**From:** [phil brooke](#)  
**To:** [Public Involvement \(UTC\)](#)  
**Subject:** Docket 151663-PSE LNG  
**Date:** Thursday, October 20, 2016 4:44:48 PM  
**Attachments:** [lng siting rules in us faulty havens venart DEIS comment 2015.pdf](#)  
[lng bunkering.jpg](#)  
[nfpa59a europe us probs research.pdf](#)

Regarding the  
Jordan Cove Export Terminal  
Draft Environmental Impact Statement  
Docket No. CP13-483

## **UNITED STATES LNG TERMINAL SAFE-SITING POLICY IS FAULTY**

**LNG tank-top fire (high wind speed) FDS model results by Venart**

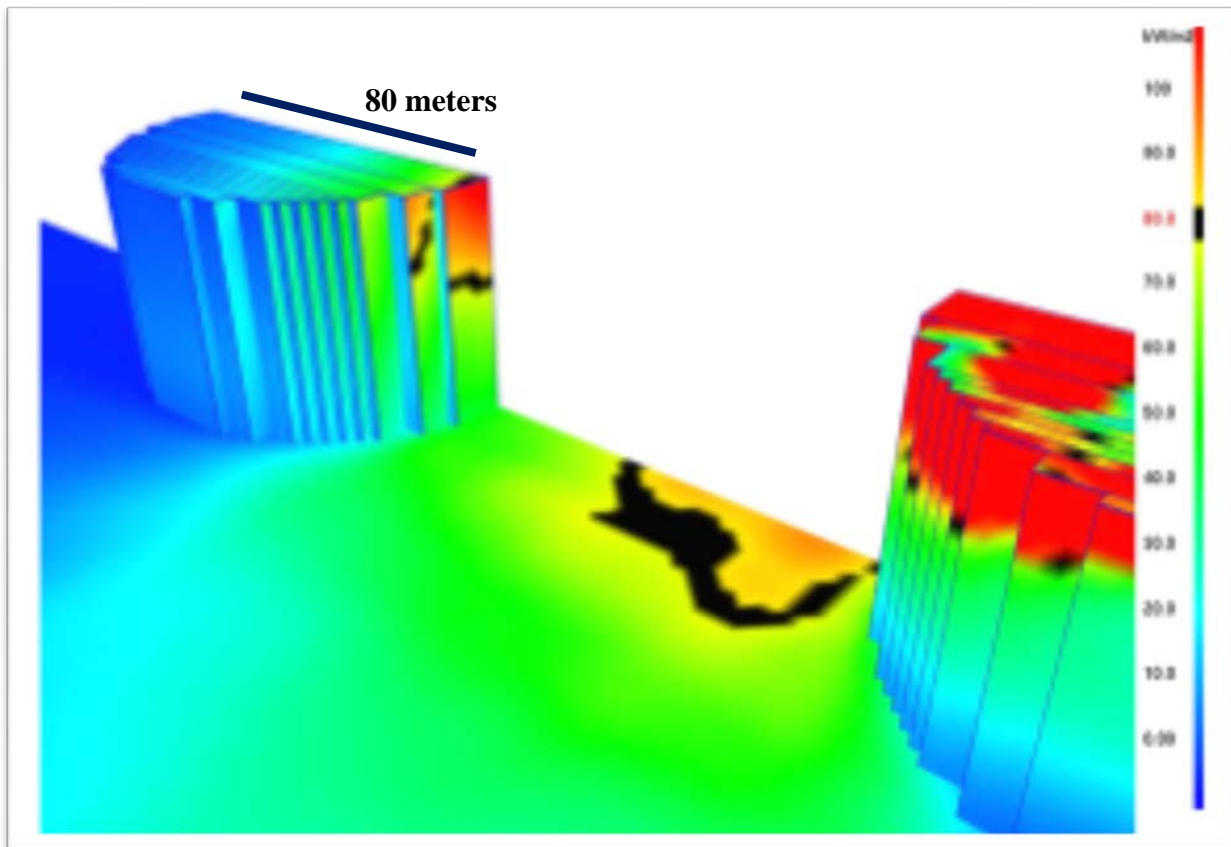
Down-wind tank being exposed to an up-wind tank-top fire  
Boundary heat flux for two tanks at 1 minute after fire initiation.  
Incident heat flux exposures to both tanks in excess of  $80 \text{ kW/m}^2$ , wind  $7.5 \text{ m/s}$ .

- If not extinguished such a tank-top fire could possibly burn for 20-30 hours.
  - NIST FDS CFD and experimental studies establish that the wind flowing around the sides of the tank tends to drag the flame down over the edge of the tank towards the ground. This exposes the concrete containment to high temperatures, radiant fluxes greater-than-design and thus thermal stresses with a potential for spalling, cracking, and other failure modes, thus loss of support to the interior mild steel moisture barrier and the insulating perlite.

- Thermal stresses to this complex system over the many hours of fire exposure could possibly cause collapse of the downwind edges of the Nickel steel primary containment and loss of LNG into the Perlite, a situation perhaps sufficient to result in total collapse of the containment system due to thermal stress. Under such conditions escalation of the event would be inevitable.

Figure 4.13-1 from DEIS  
Vapor Fences at Jordan Cove Facility

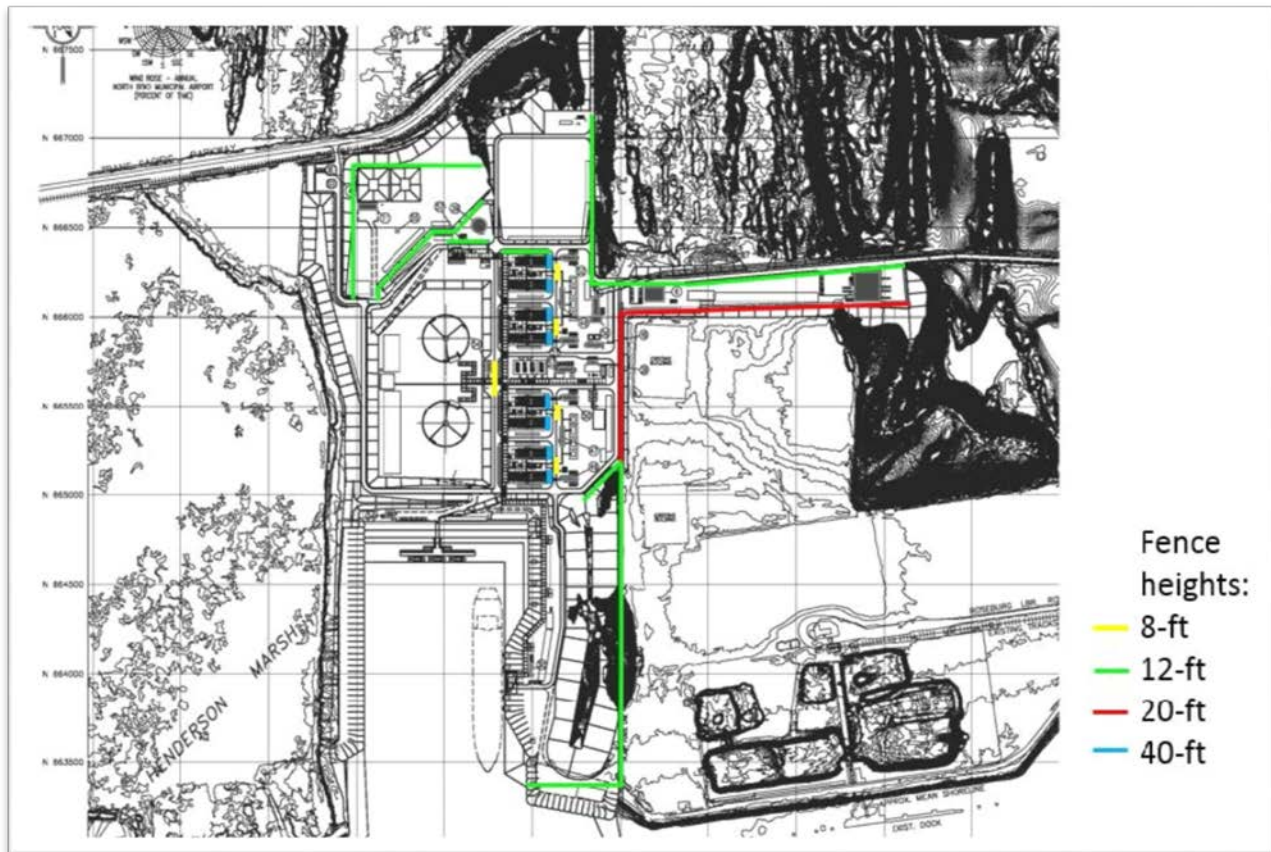
The vapor dispersion distances calculated using PHAST and FLACS, while extending in some cases slightly past the applicant’s property boundaries, obviously could not have been determined by the (dispersion) models used without the applicant’s provision of gas-impermeable vapor fences to retain the flammable cloud boundaries within the property boundary. The Figure below indicates the position of the proposed vapor fences; gas-impermeable concrete fences as tall as forty feet.

Perhaps most importantly, as vapor fences at the Jordan Cove Facility could (in addition to the spill-guidance trenches and impoundments themselves) provide a degree of partial confinement to the cloud, there is additional potential for run up to detonation, especially if the cloud contains more than a few percent ethane/propane or equivalent heavy components.

Figure 4.13.5 from DEIS  
LNG Spill from a Guillotine Rupture of the Ship Loading Header

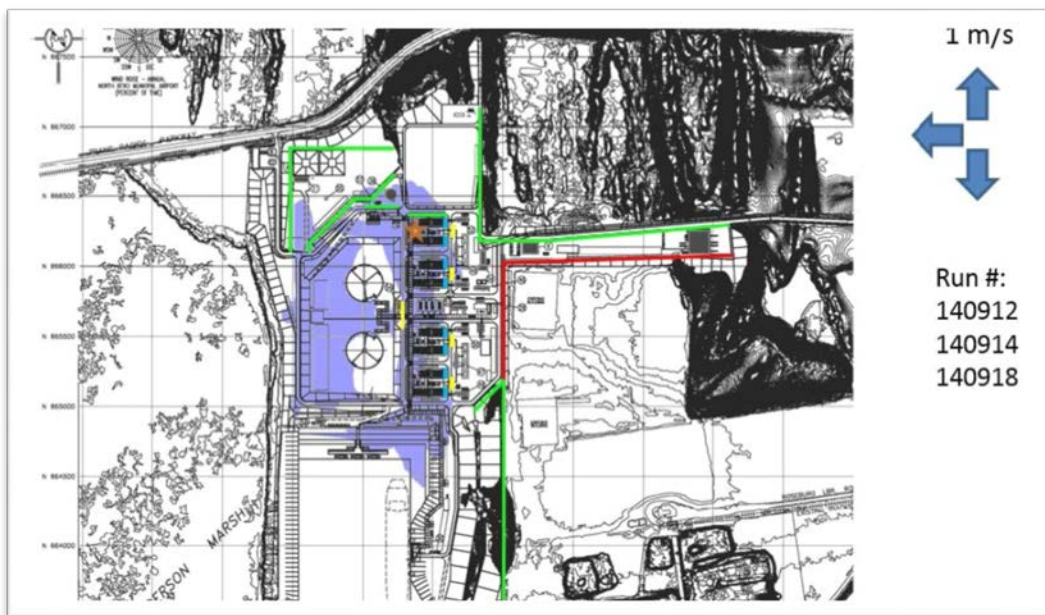
The area covered by the cloud in Figure 4.13.5 is estimated to be approximately 320 meters wide and 480 meters long (top to bottom in the figure). We estimate this gas cloud would be between 2 and 4 meters deep. The cloud envelops a large portion of the liquefaction trains; these trains are dense packed equipment structures which are known to accelerate flames in such a gas cloud sufficiently to cause damaging overpressures. The cloud essentially surrounds the LNG storage tanks.

Figure 4.13-10 from DEIS

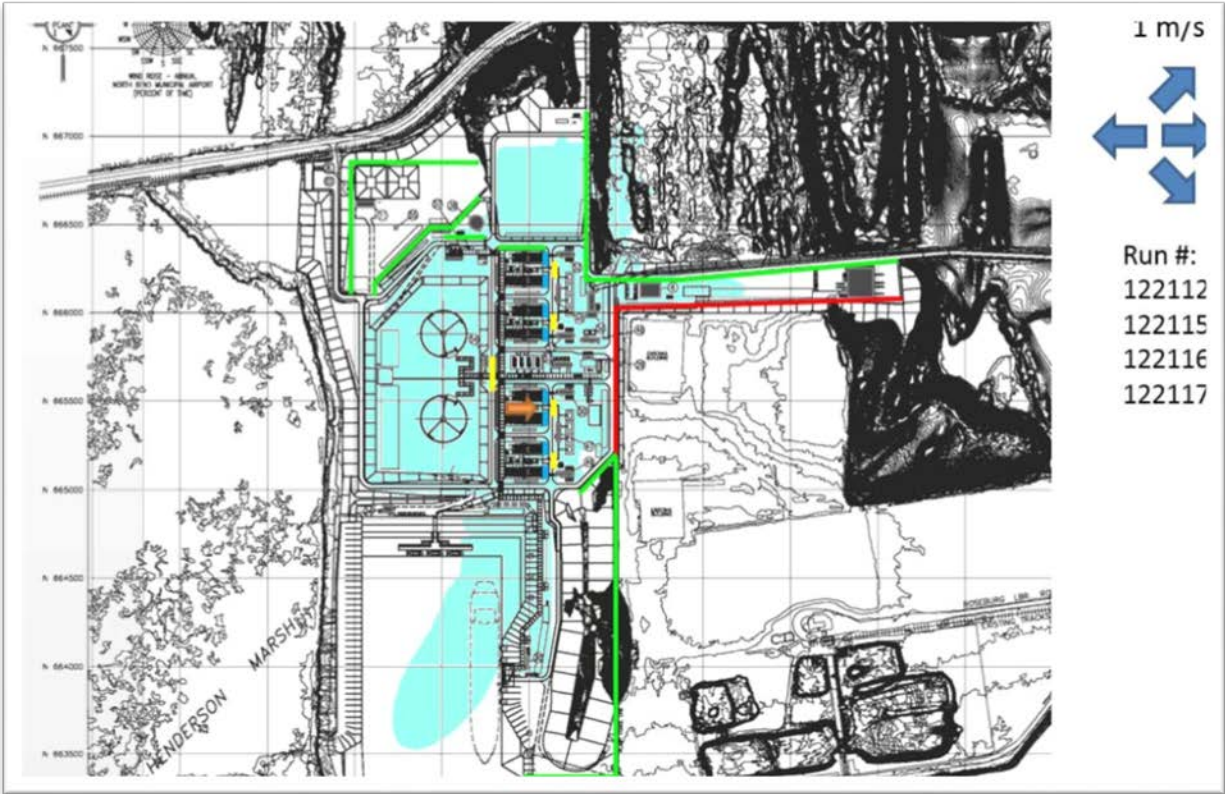
The area covered by the cloud in Figure 4.13.10 is estimated to be approximately 400 meters wide and 720 meters long (top to bottom in the figure). We estimate this gas cloud would be between 2 and 4 meters deep. The cloud envelops large portions of the liquefaction trains as well as at least half of the LNG shipping berth, including the space between the ship and the sea wall. We believe that an unignited MRL vapor cloud as indicated here could have the potential to cause a catastrophic UVCE that would result in severe cascading effects endangering the entire terminal.

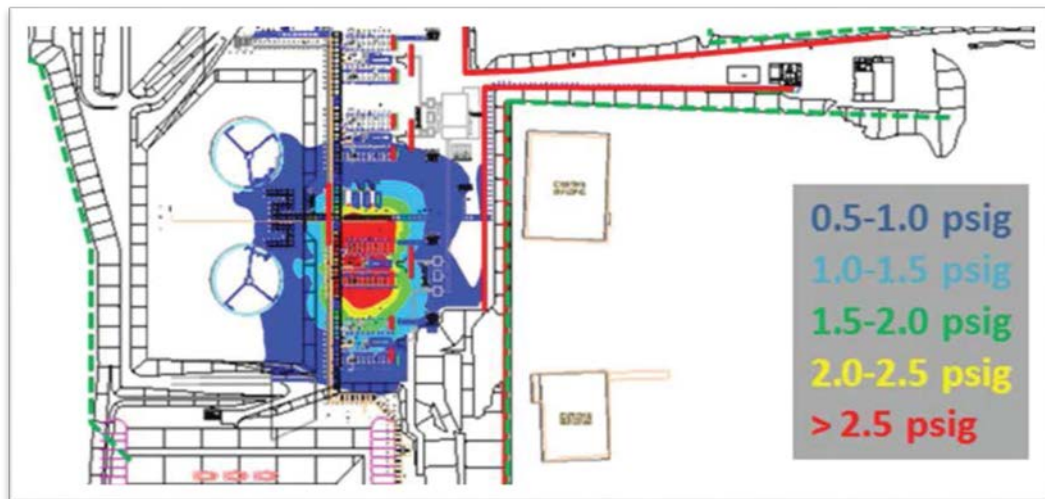
The DEIS presents a single vapor cloud prediction for the 14,000 gallon ethylene design spill. The wind speed is specified as 1 m/s (essentially calm). The area covered by the cloud in Figure 4.13-13 is estimated to be approximately 320 meters wide and 400 meters long (top to bottom in the figure). We estimate this gas cloud to be between 2 and 4 meters deep as well. The cloud envelops large portions of the liquefaction trains as well as all of one of the LNG tanks and about ¼ of the other one. The DEIS states that the ethylene release scenario at the refrigerant trucking area would remain within Jordan Cove's property or extend over a navigable body of water, so it would not have a significant impact on public safety with respect to flammable vapor dispersion.
